**Eugene School District 4J
ROOSEVELT MIDDLE SCHOOL**
680 East 24th Avenue
Eugene, OR 97405
CIP No. 410.566.001

ADDENDUM NO. 6

This Addendum forms a part of the Contract Documents and modifies the original Bidding Documents dated February 18, 2015 and subsequent addenda as noted below. Acknowledge receipt of this Addendum in the space provided on the Bid Form. Failure to do so may subject the Bidder to disqualification.

P-121A

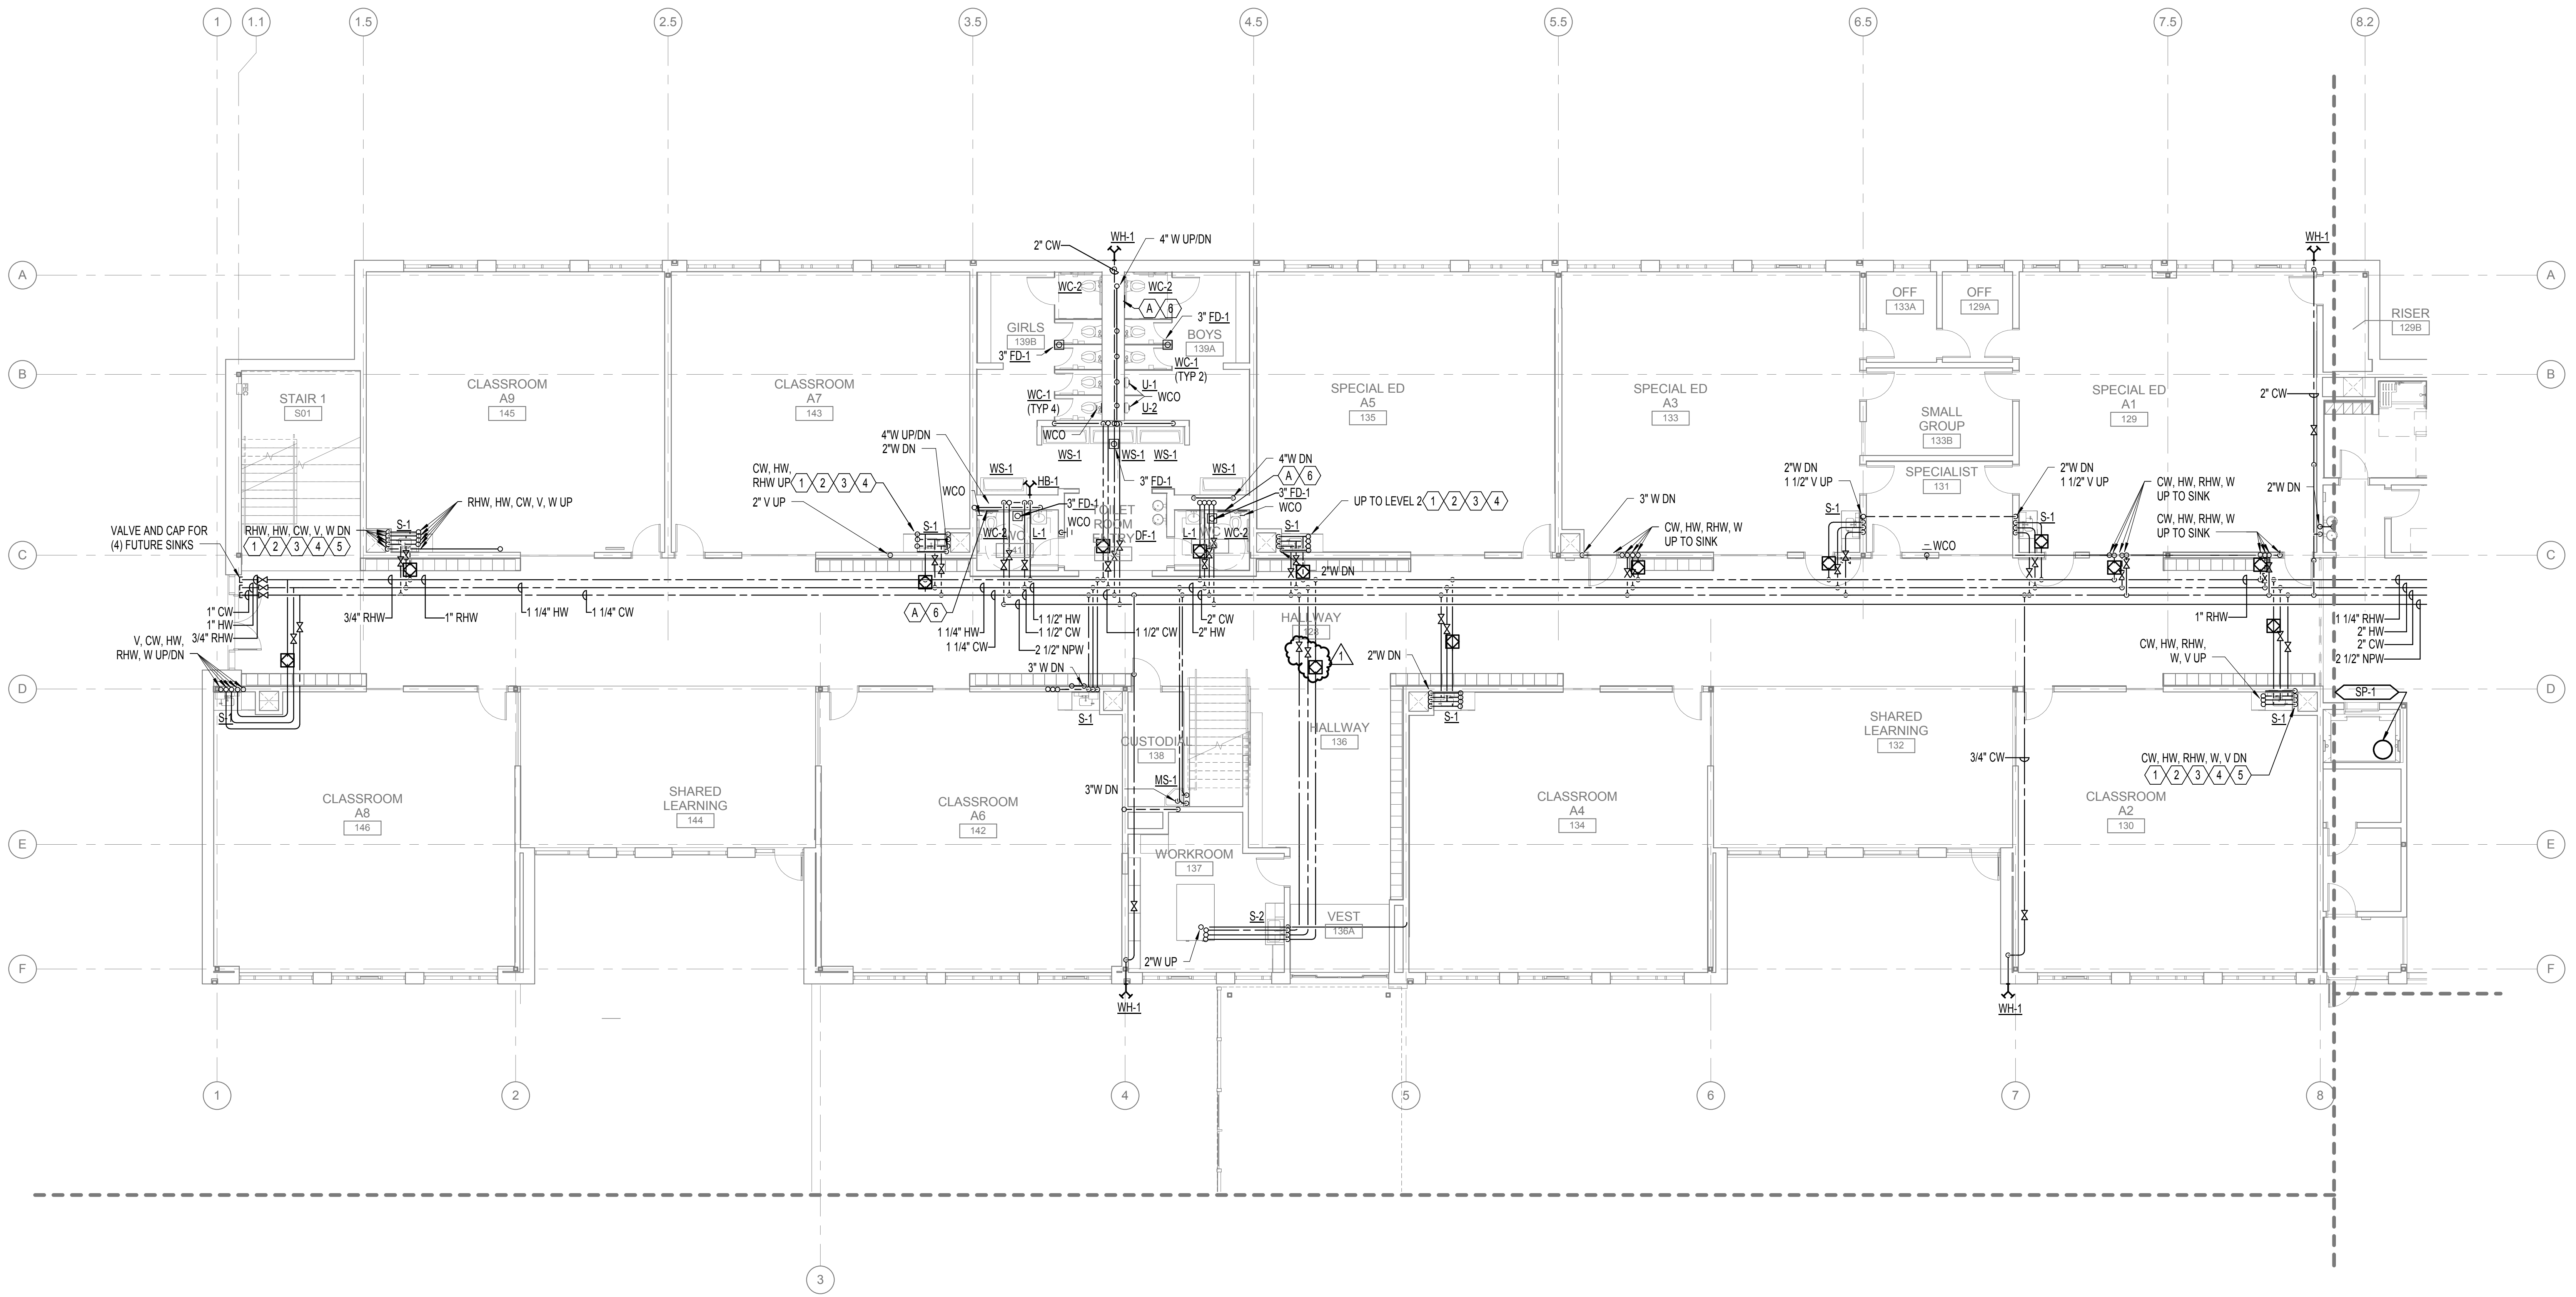
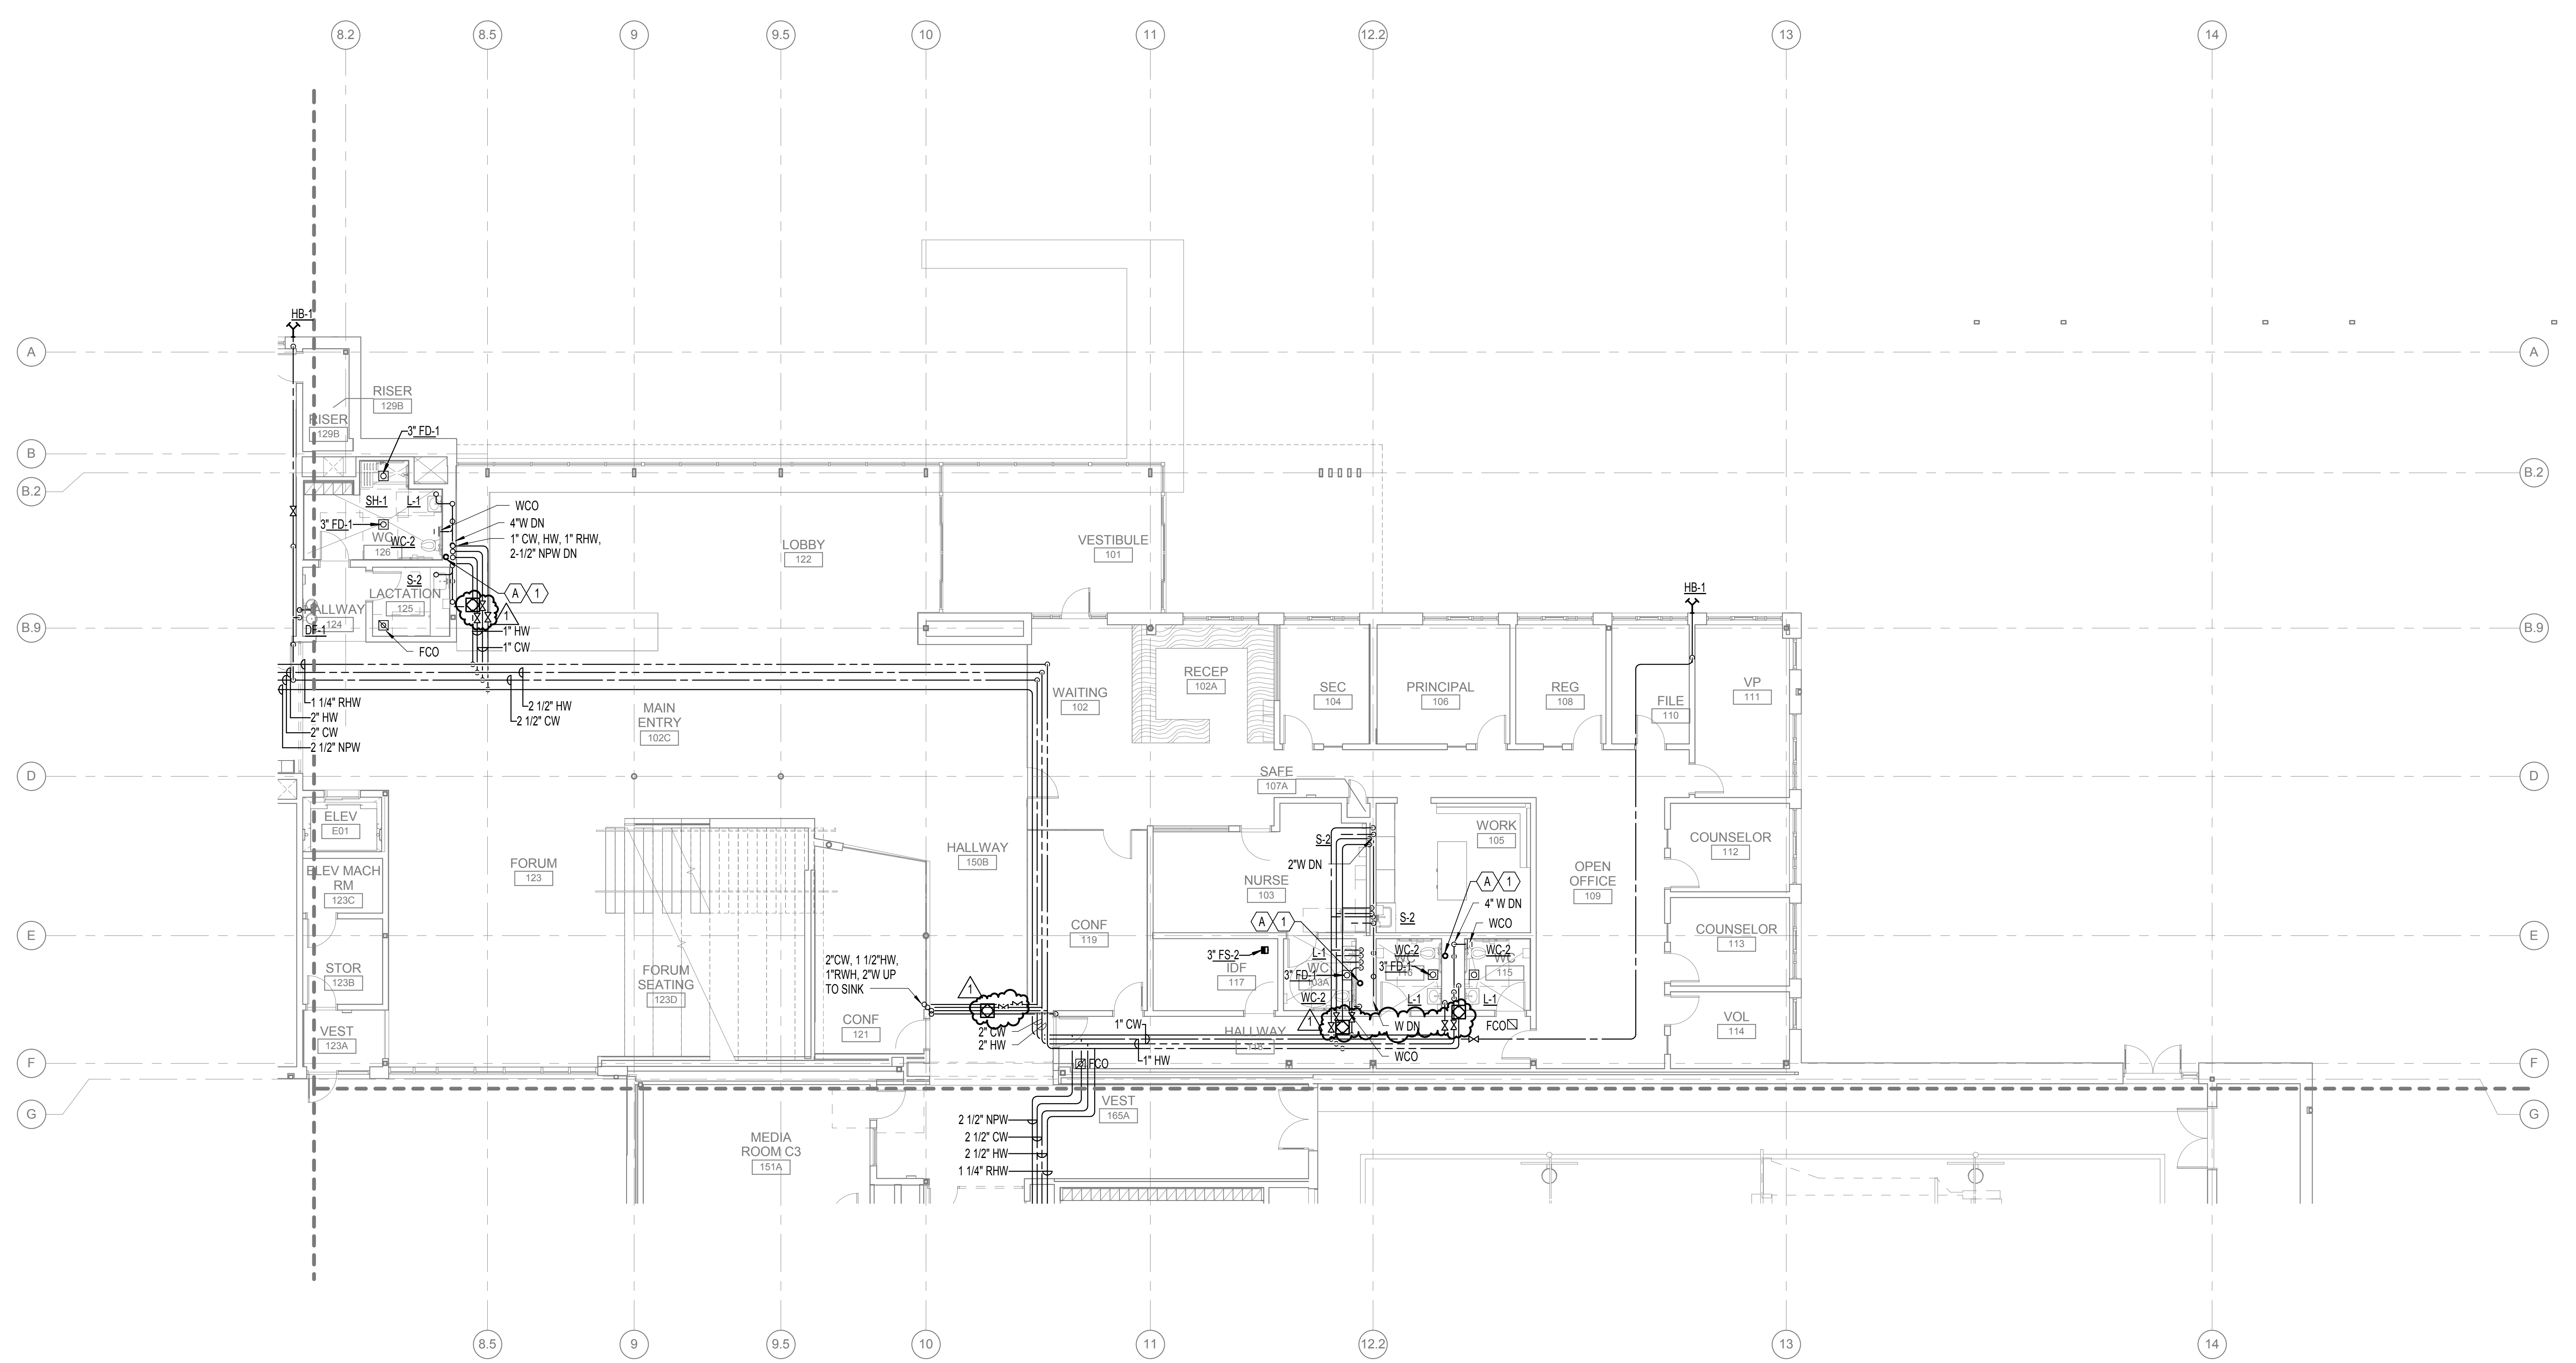
- A. Replace Sheet with revised Sheet P-121A: Add isolation valves and balancing valves

P-121B

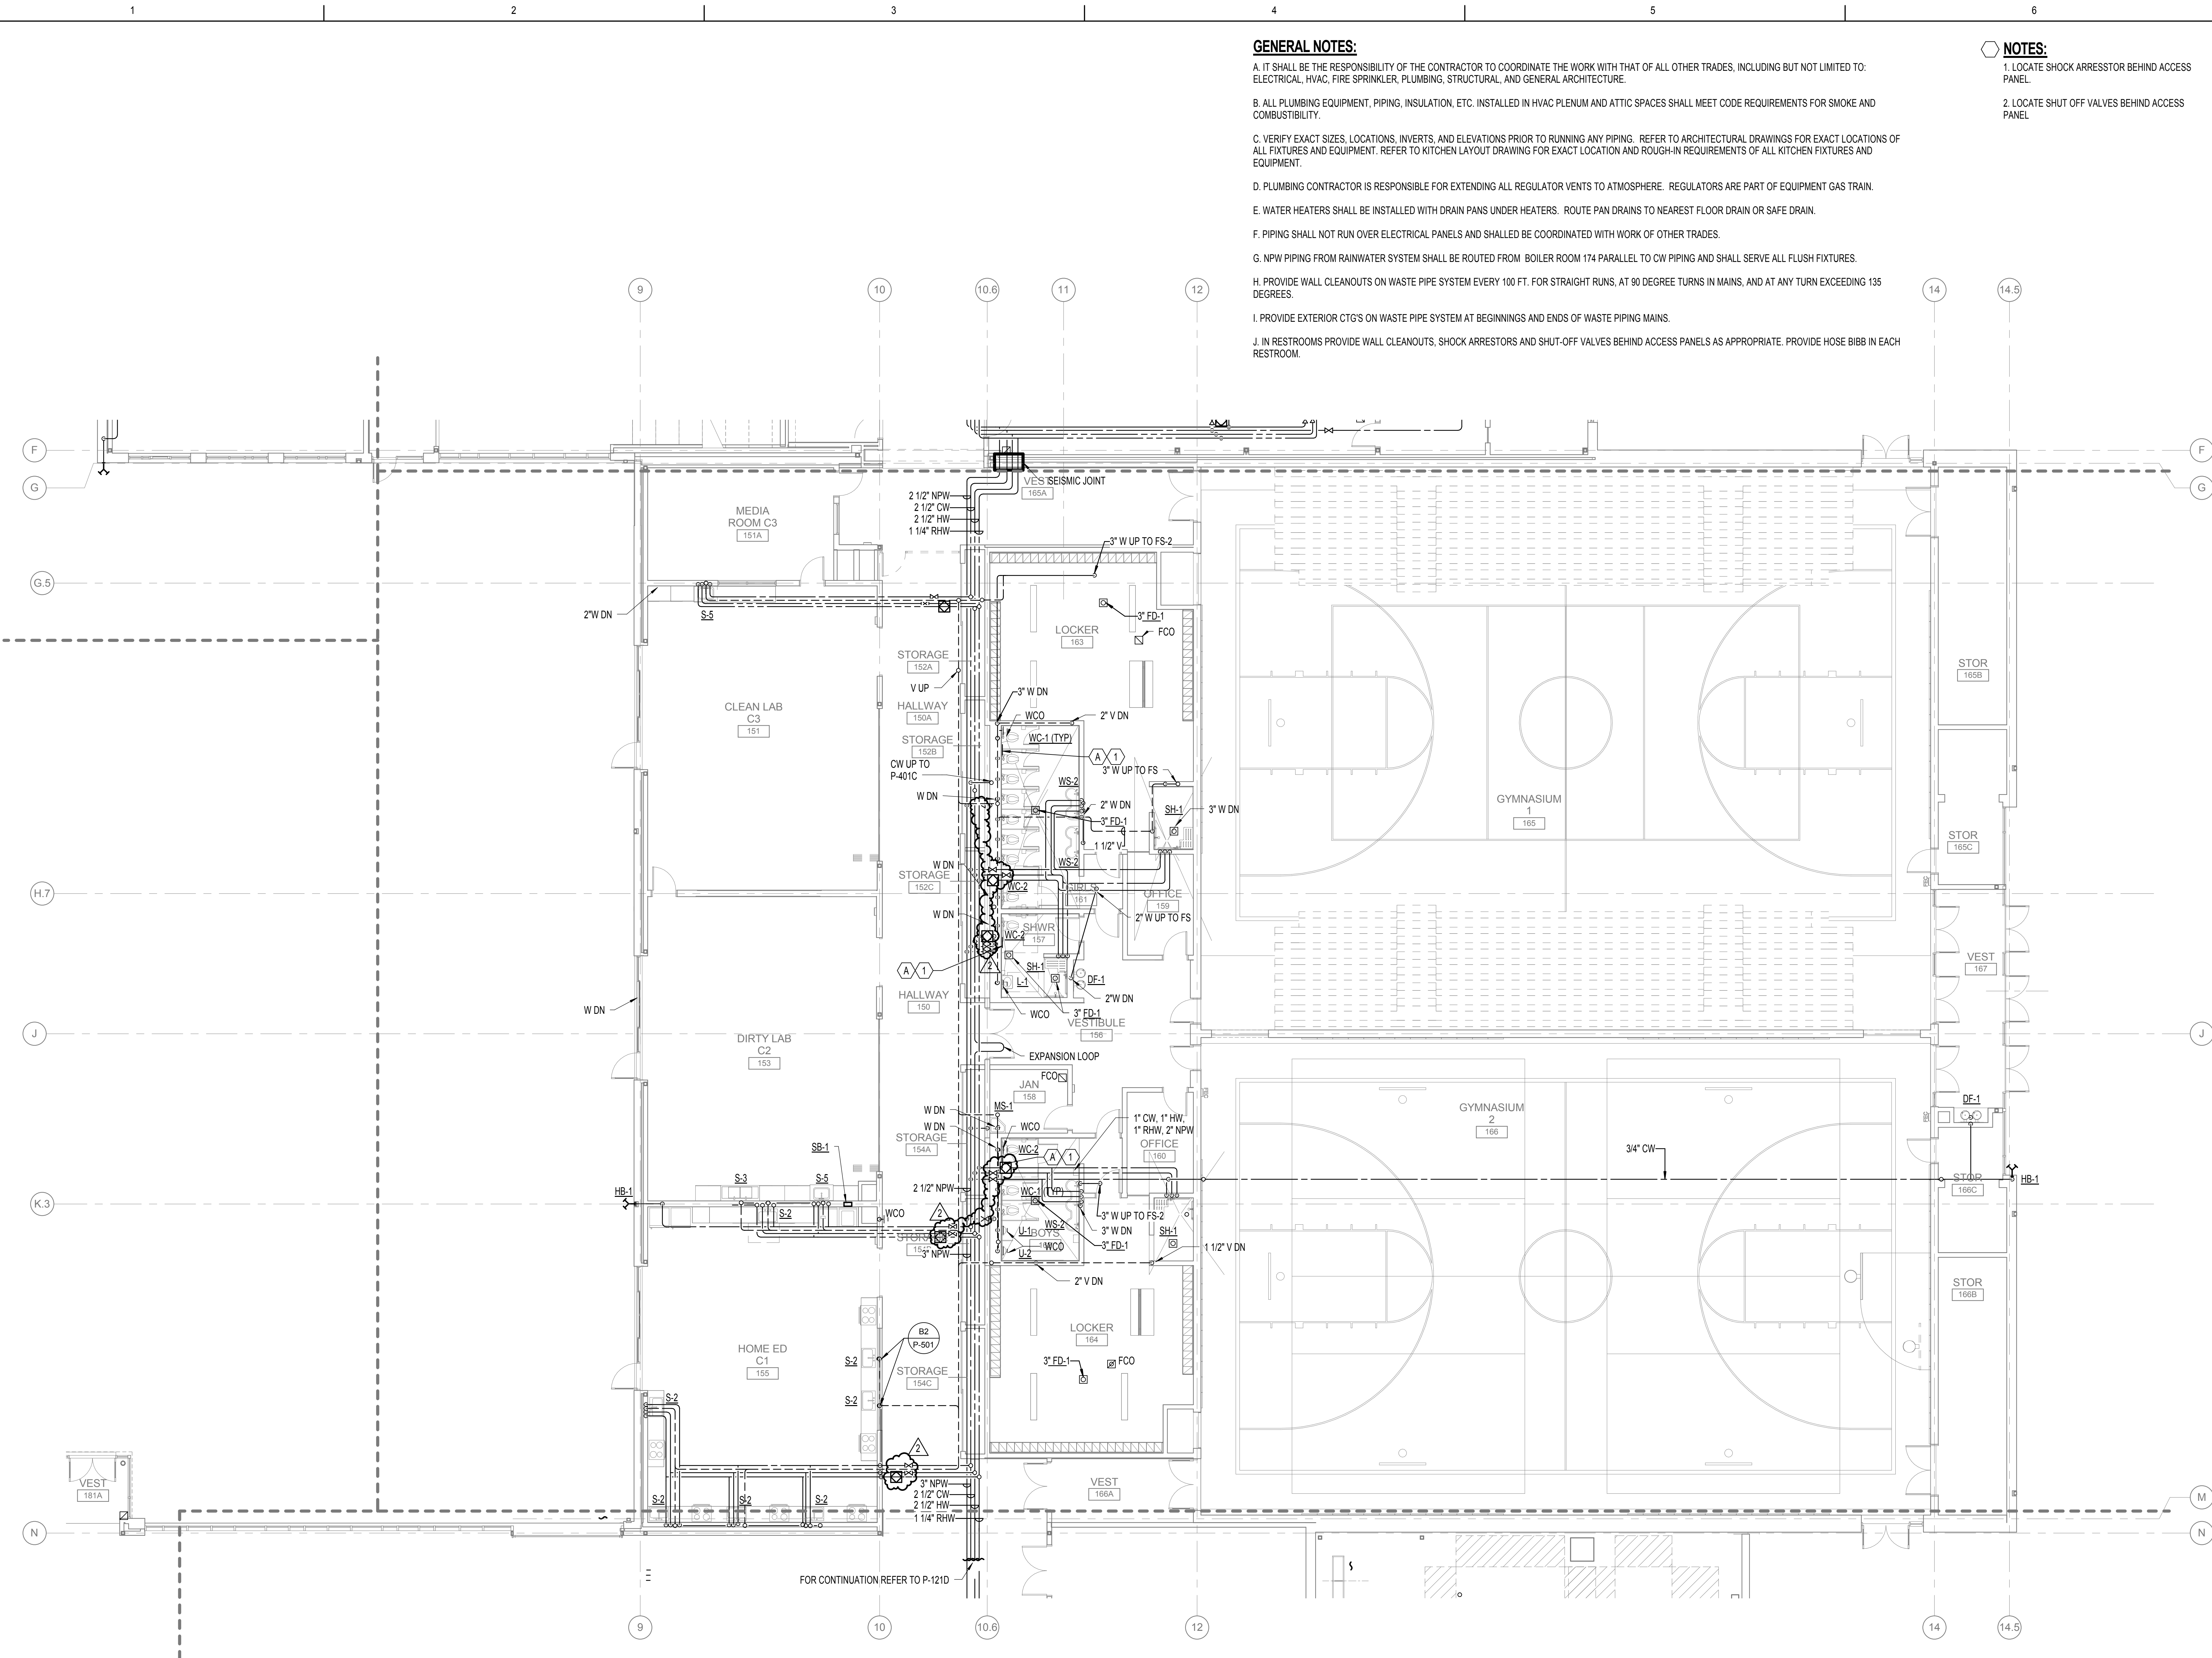
- A. Replace Sheet with revised Sheet P-121B: Add isolation valves and balancing valves
